AMENDMENT OF SOLICITATION/MODIFICATION OF CONTRACT

2. AMENDMENT/MODIFICATION NUMBER
00073. EFFECTIVE DATE
04-05-2021

The purpose of this amendment is to provide the following:

1. A copy VA Addendum 2 combined document as well as the Addendum 2 Attachments and Narrative Documents.
2. A copy of 23 07 11 HVAC and Boiler Plant Insulation Document.
3. A copy of the Exterior Site Plan Dumpster Laydown Document.
4. A copy of the Minneapolis Mental Health Technical Questions Spreadsheet.
5. A copy of the Addendum 2 Revision Set 2
6. Technical question due date has been extended from April 6, 2021 to April 8, 2021 at 2:00 PM ET.

Project No. 618-17-127		Building Number 70	
DRAWING NO. 1338 - PP103-P2

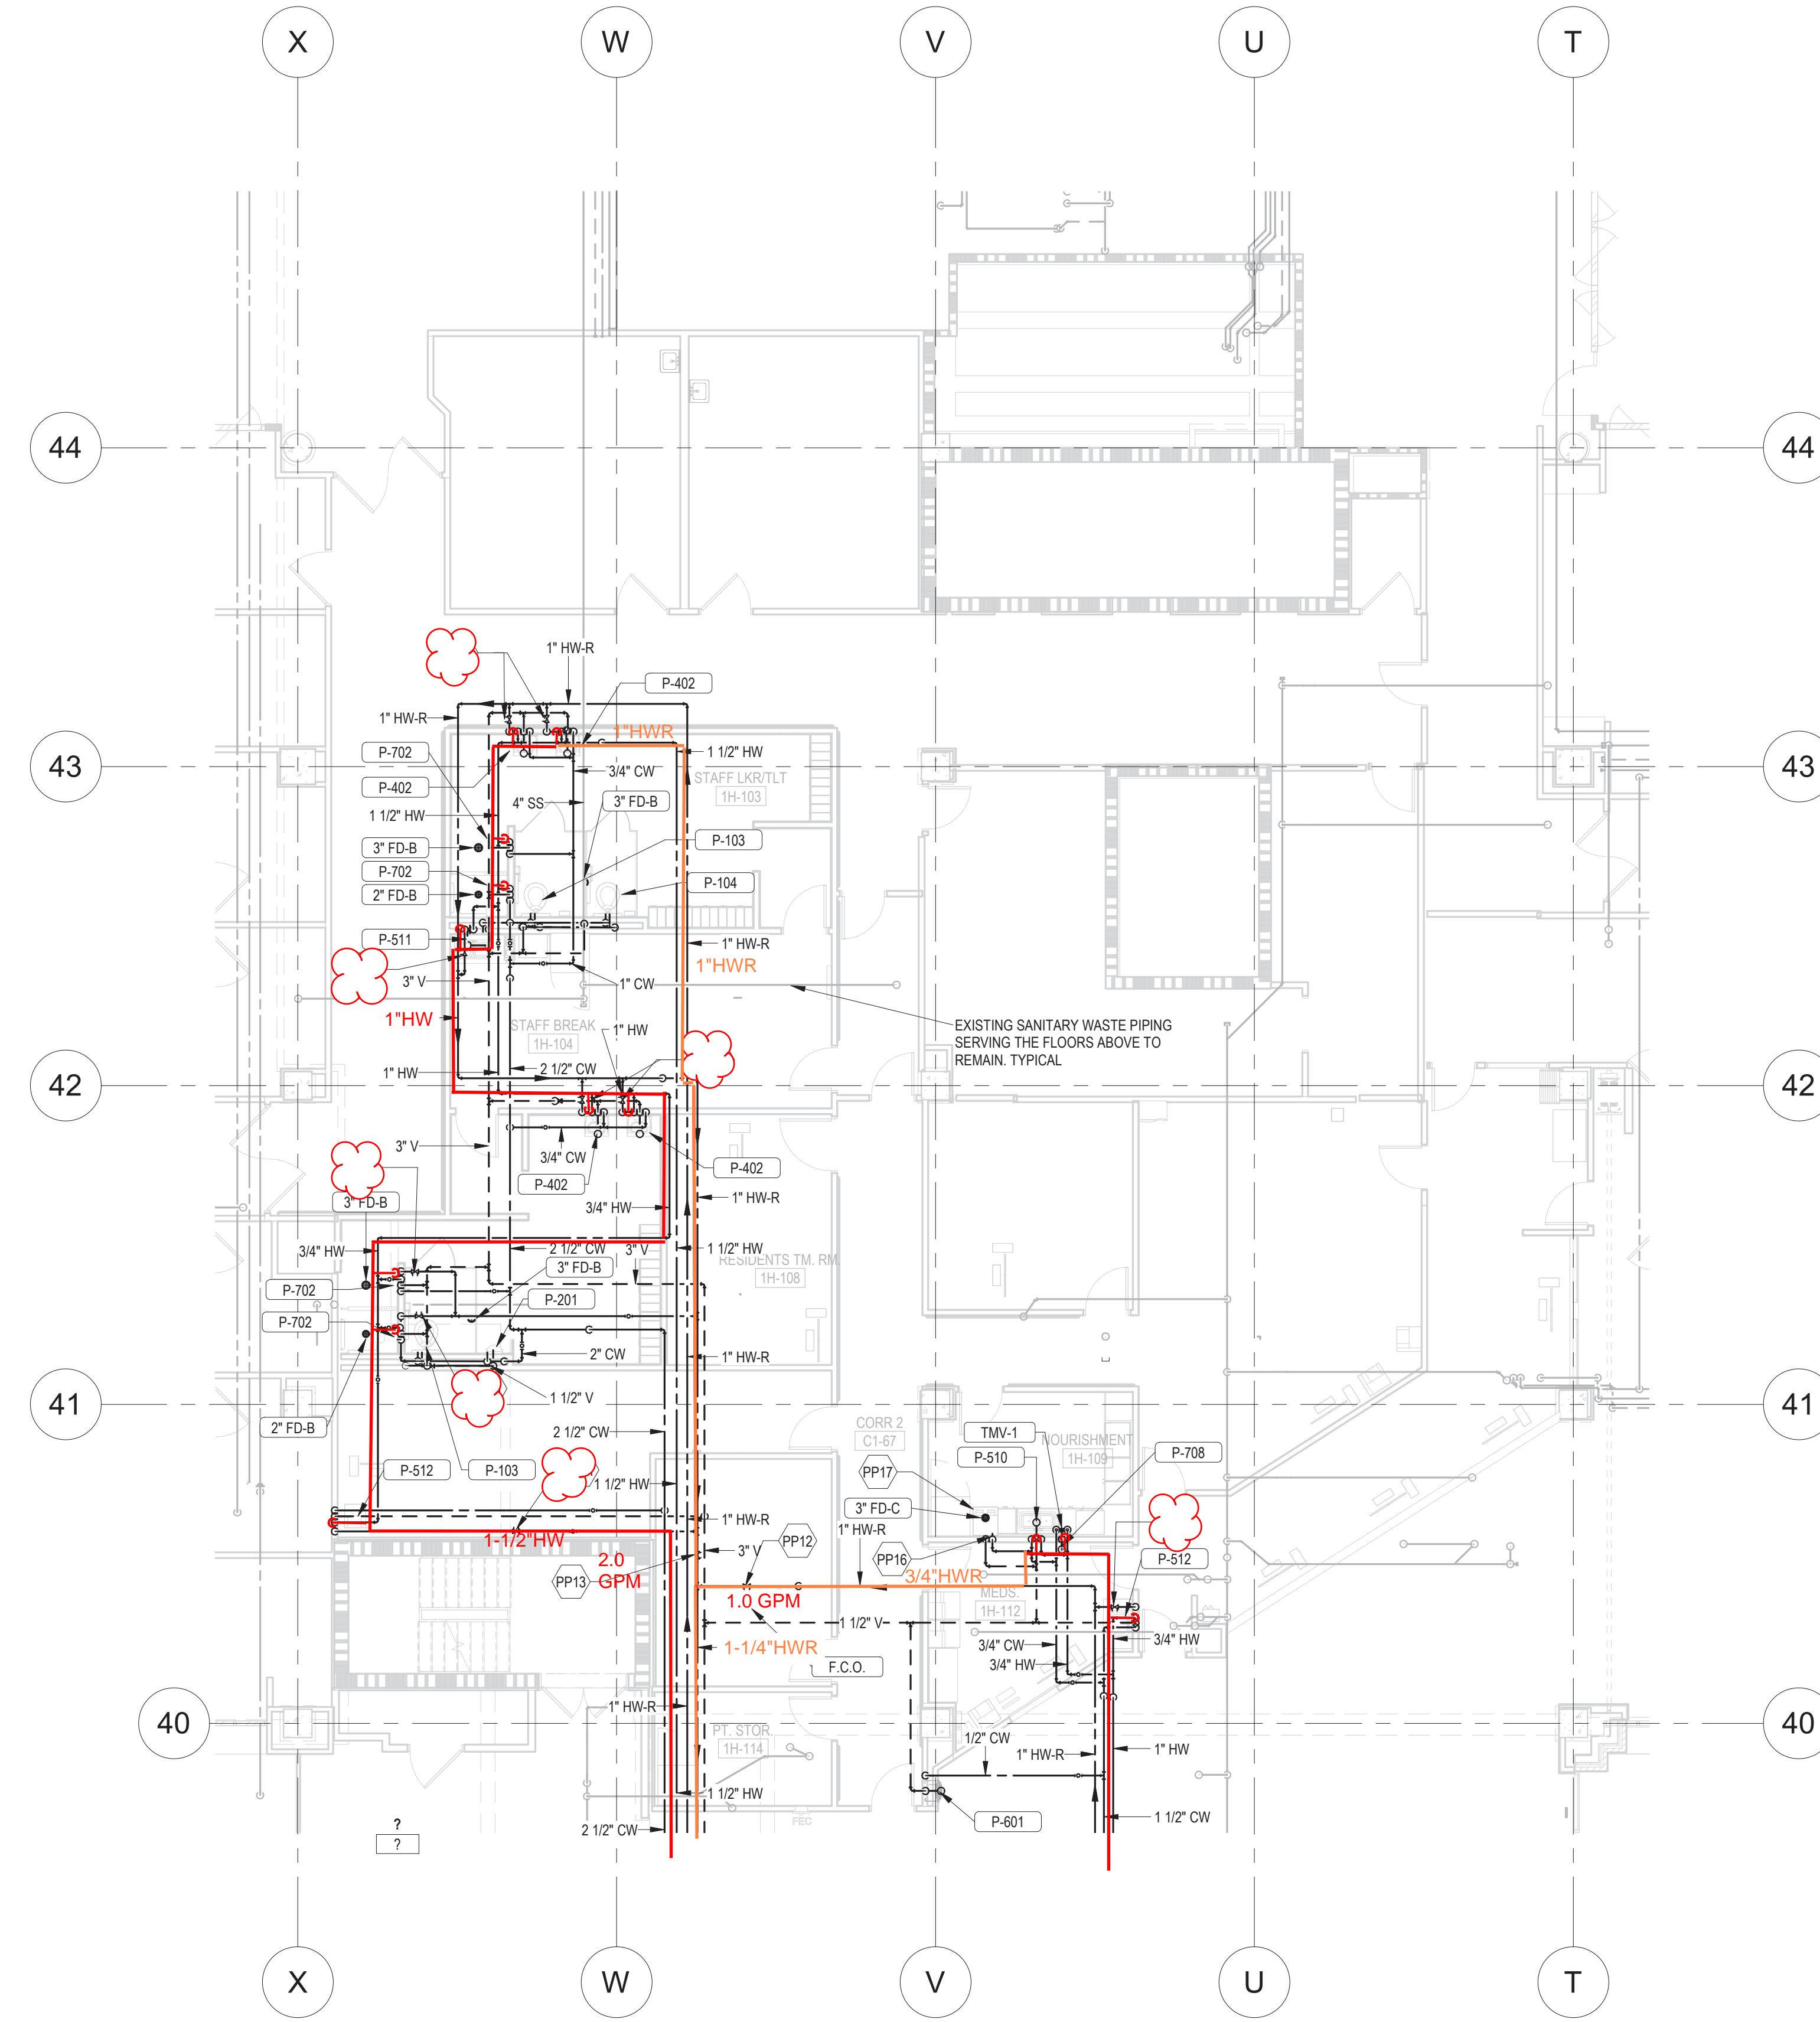
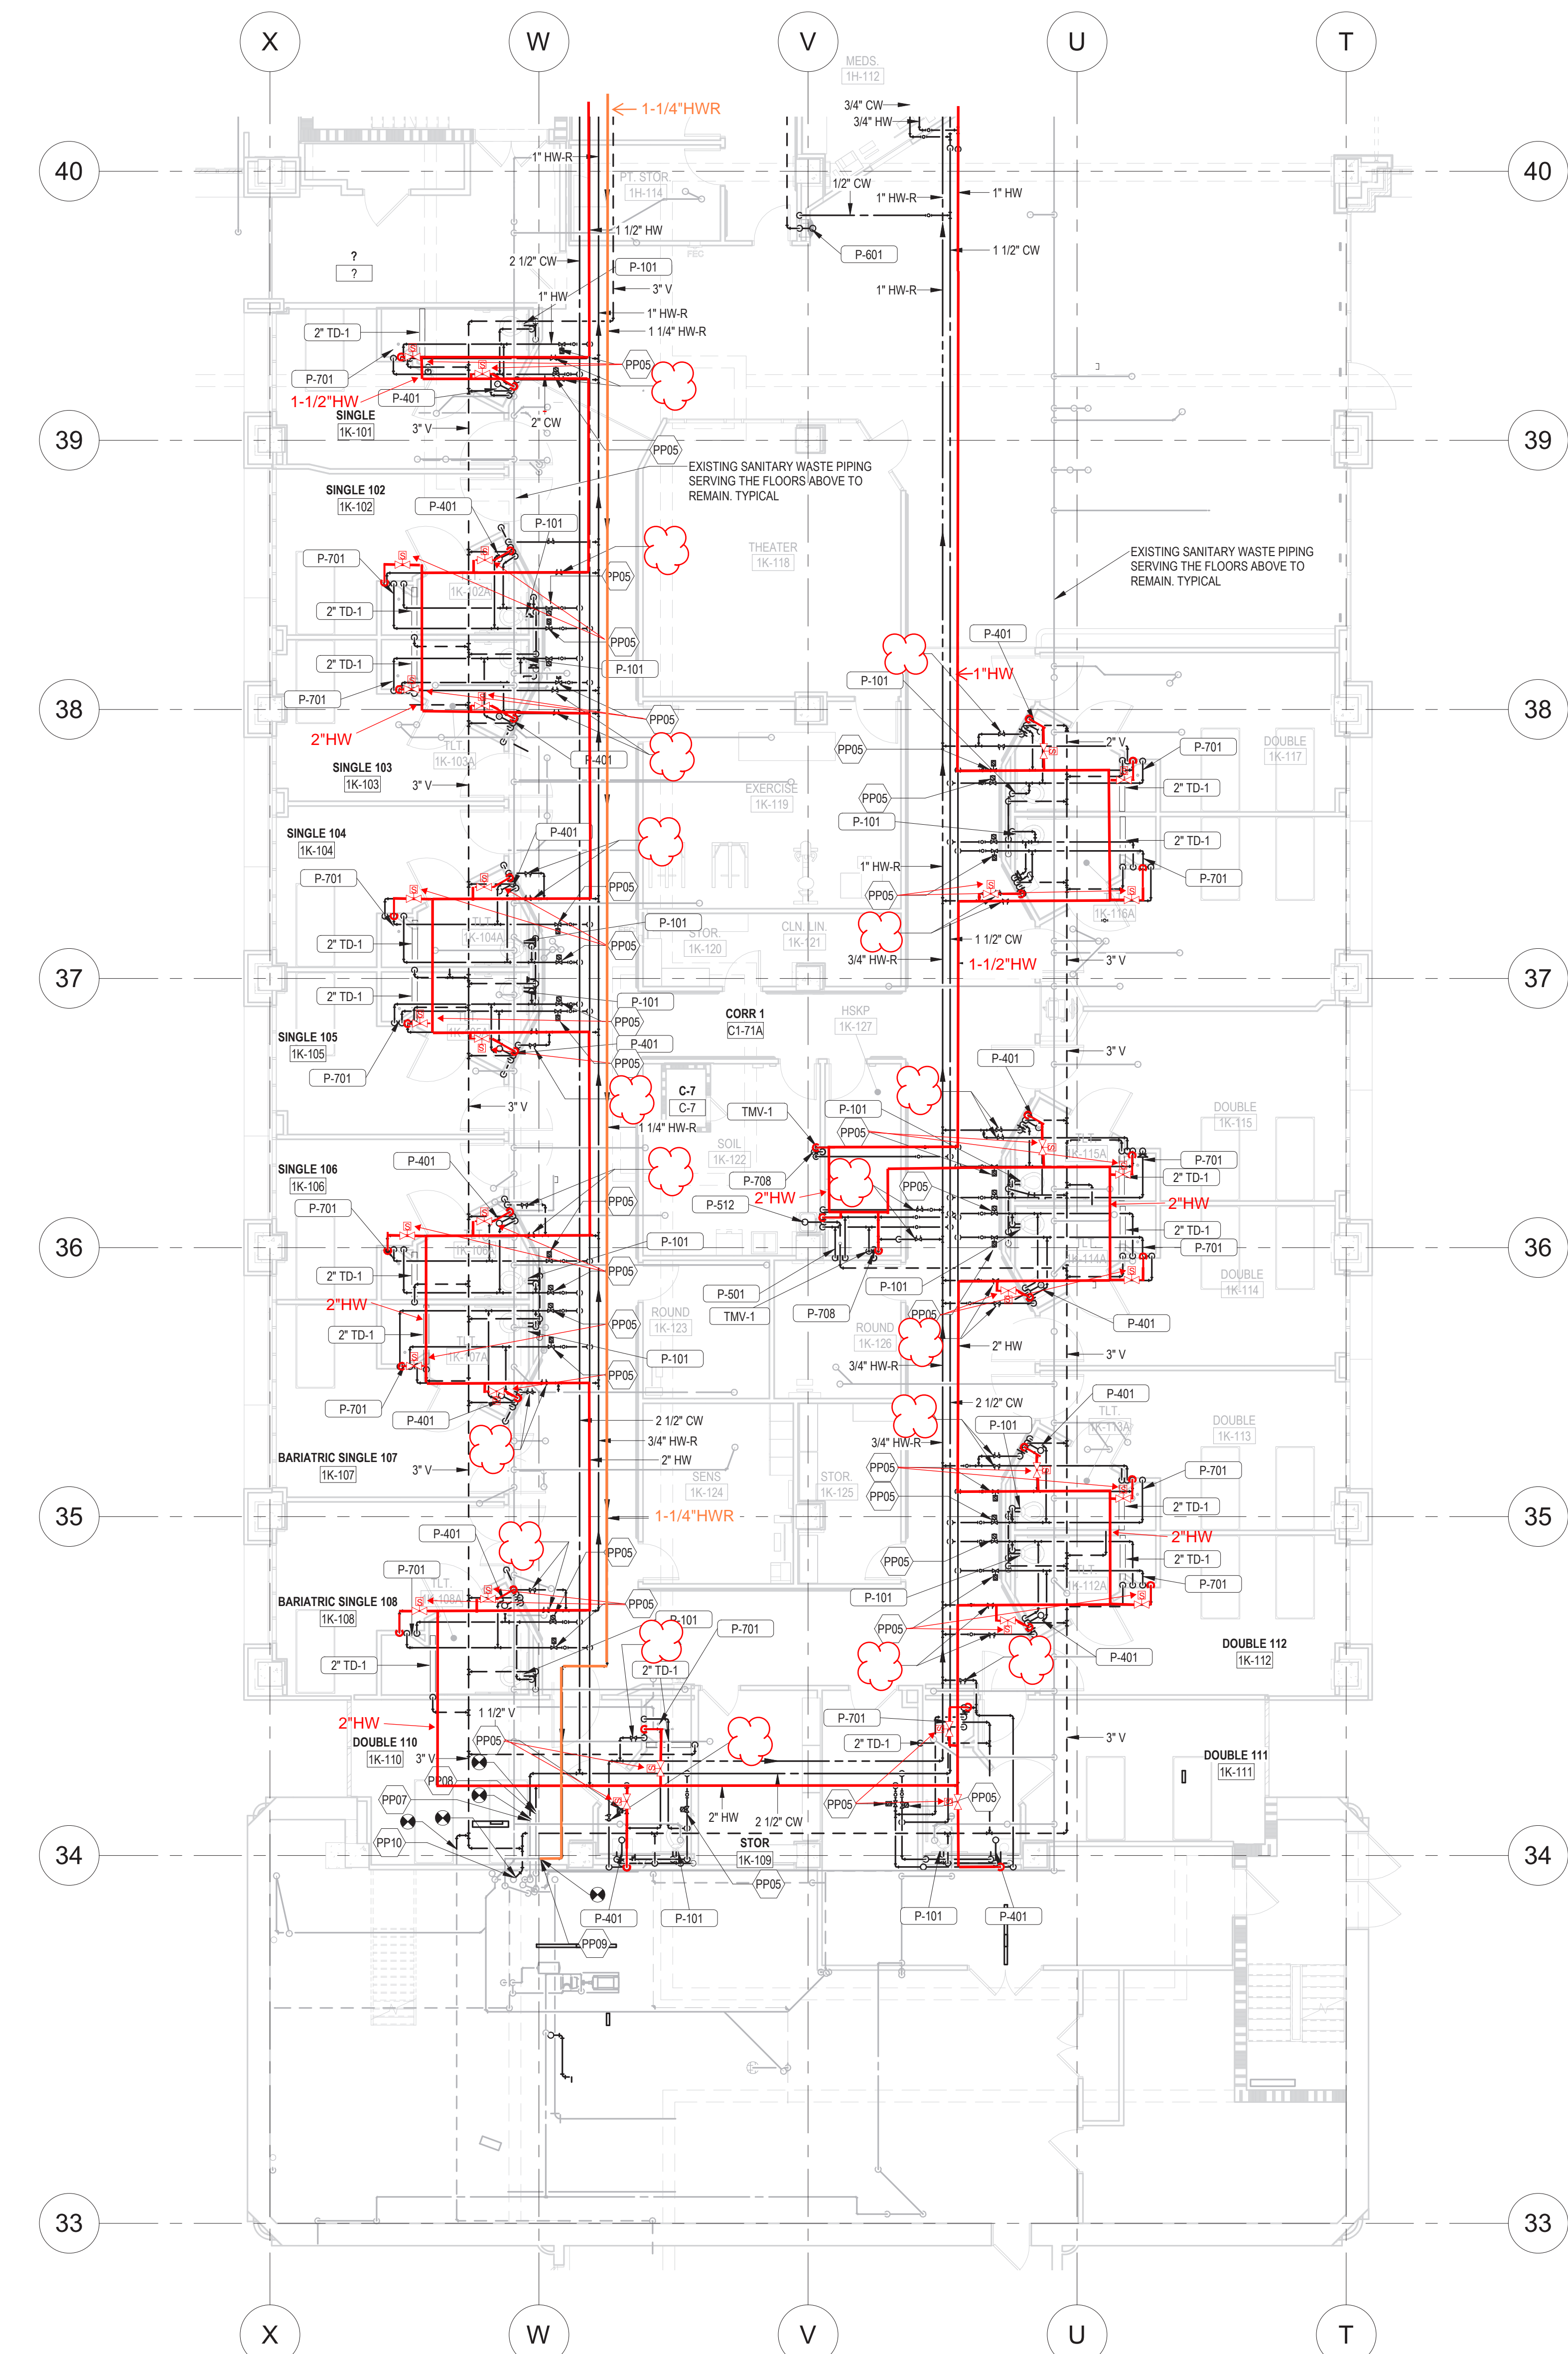
- SHEET PP103-P2 – PLUMBING PLANS – LEVEL 1 - AREA H - PHASE 2
 - Similar to comments for PP102-P2, disregard key note to install a circuit setter at each sink. Provide ASSE 1070 mixing valve at each sink. Refer to PP103-P2 rev 1 for redesign of domestic water (red lines) and hot water recirculation system (orange lines). extend hot water piping so that it is positioned above the plumbing fixture that it serves, to minimize standing water and comply with the VA Plumbing Design Manual requirements.

1 LEVEL 1 PLUMBING PLAN, AREA K, PHASE 2
SCALE: 1/8" = 1'-0"

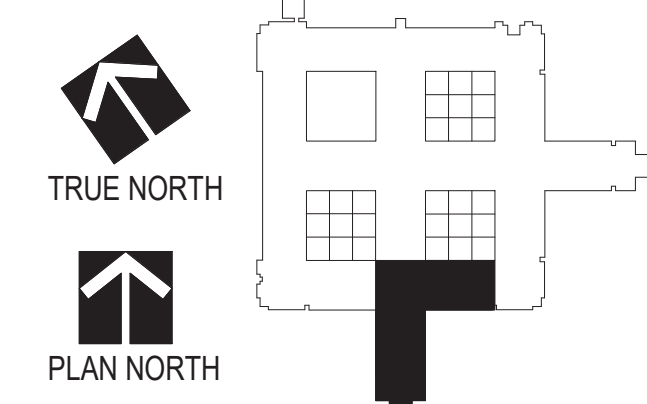
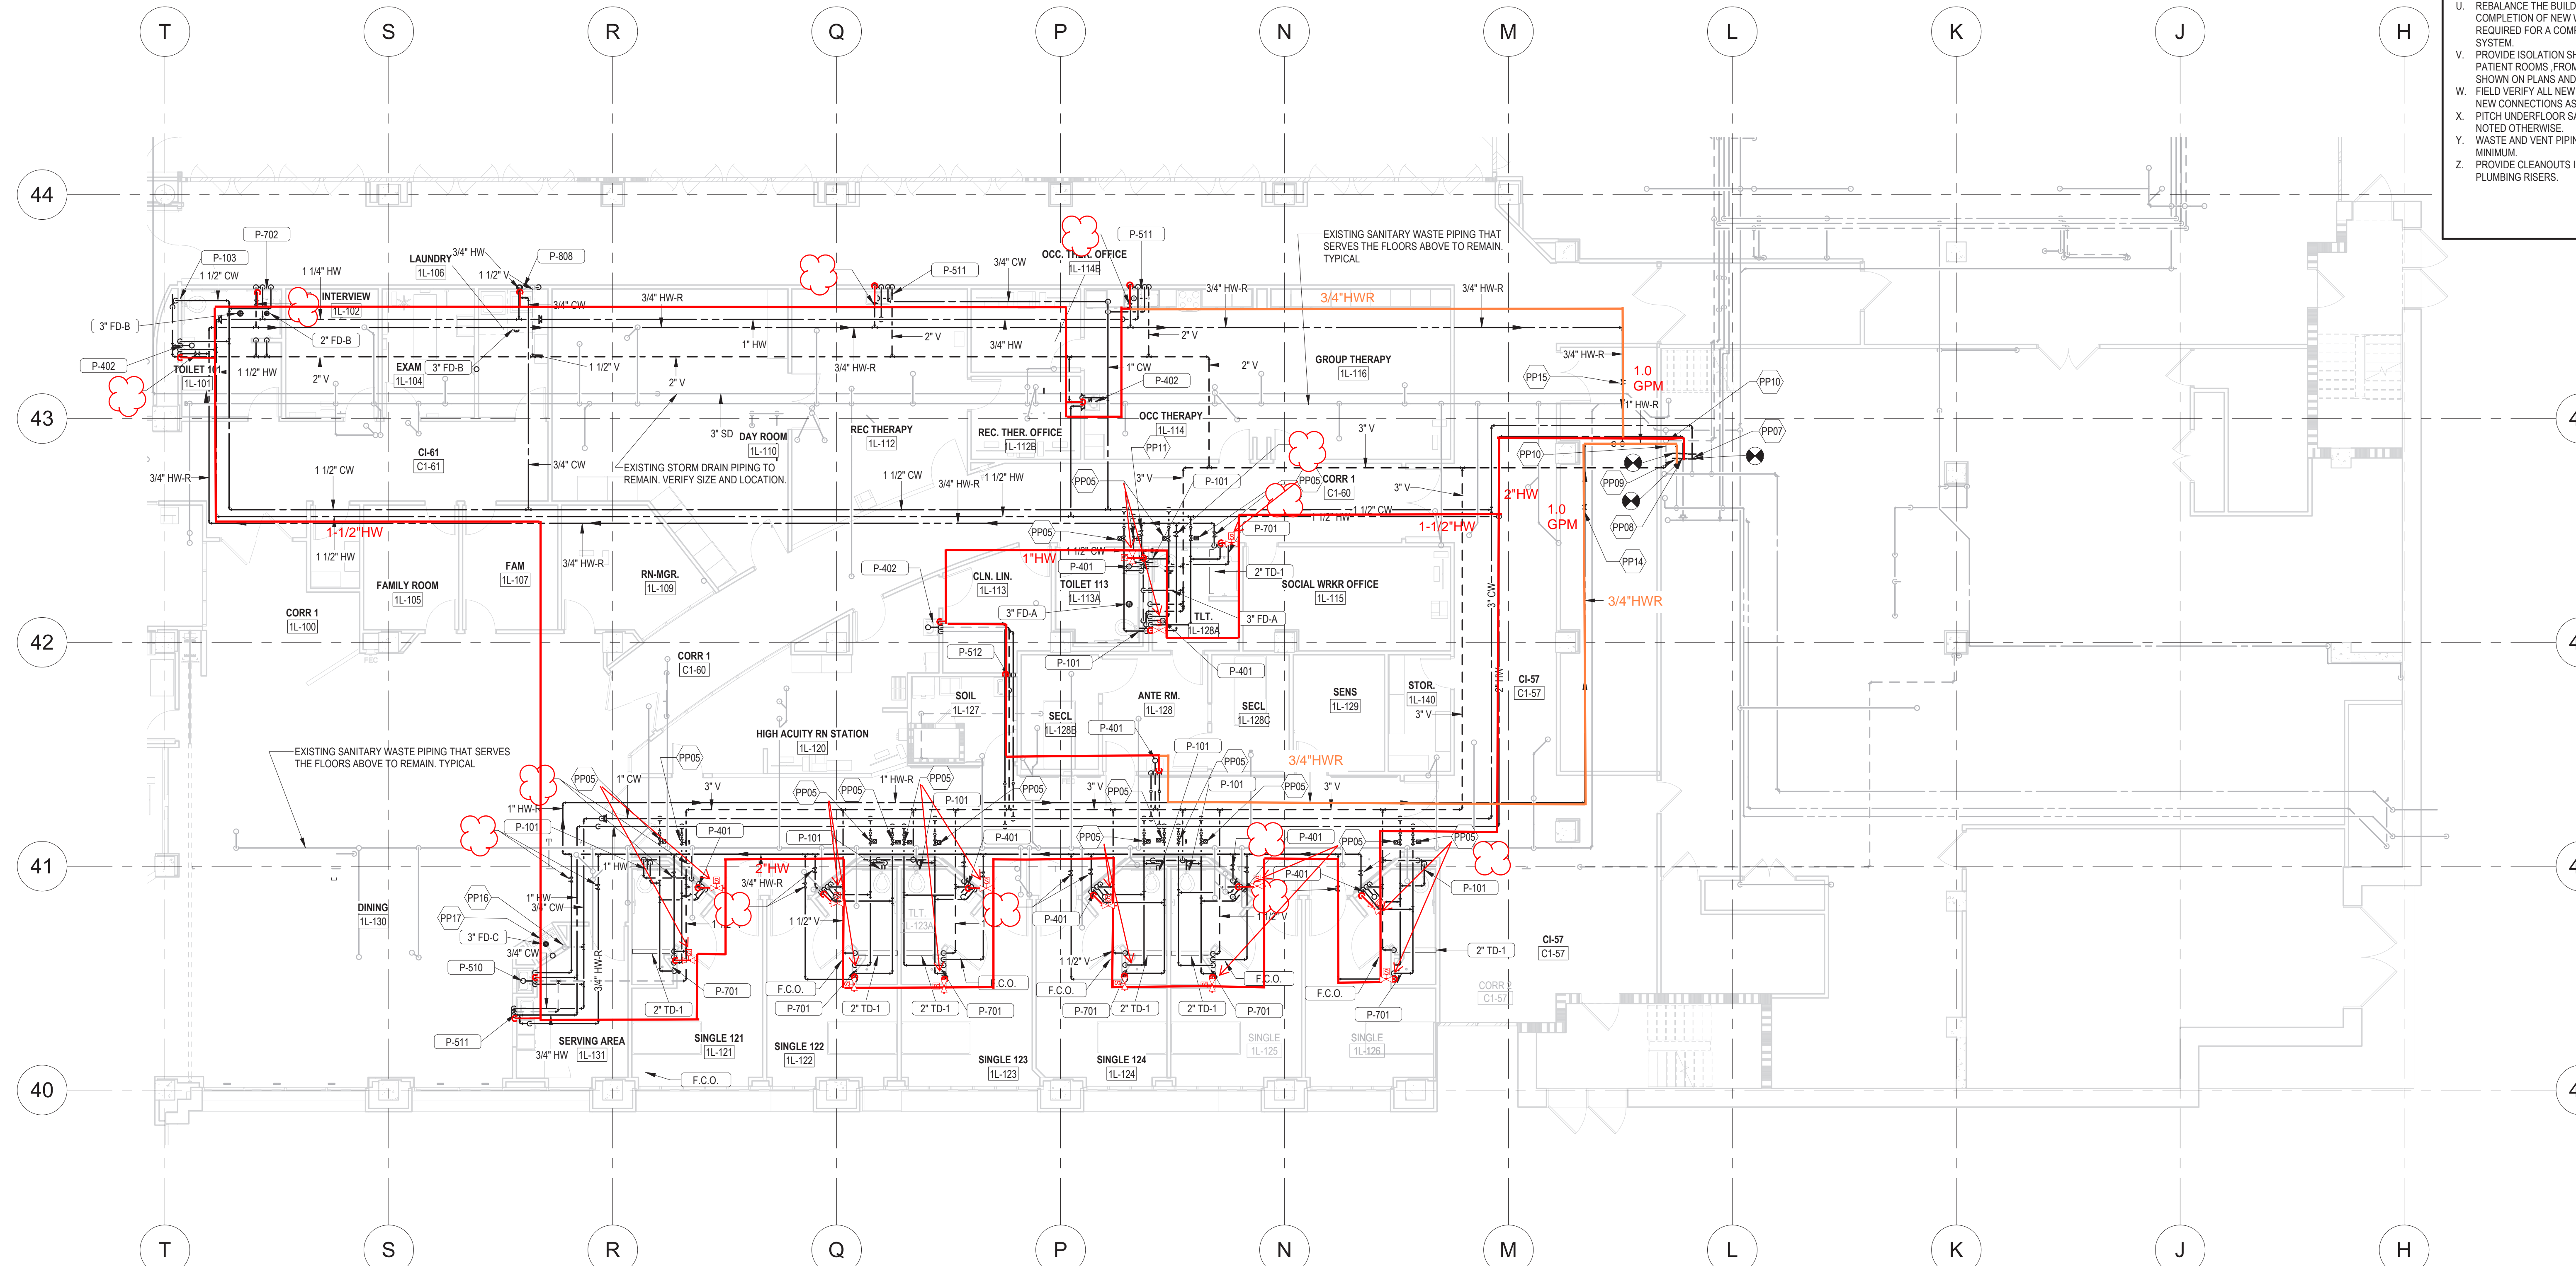
- SHEET PP102-P2 – PLUMBING PLANS – LEVEL 1 - AREA K - PHASE 2
 - Disregard key note direction to connection to existing domestic water pipe mains. Provide new cold water, hot water and recirculating hot water mains and connect to existing at the perimeter of the project area.
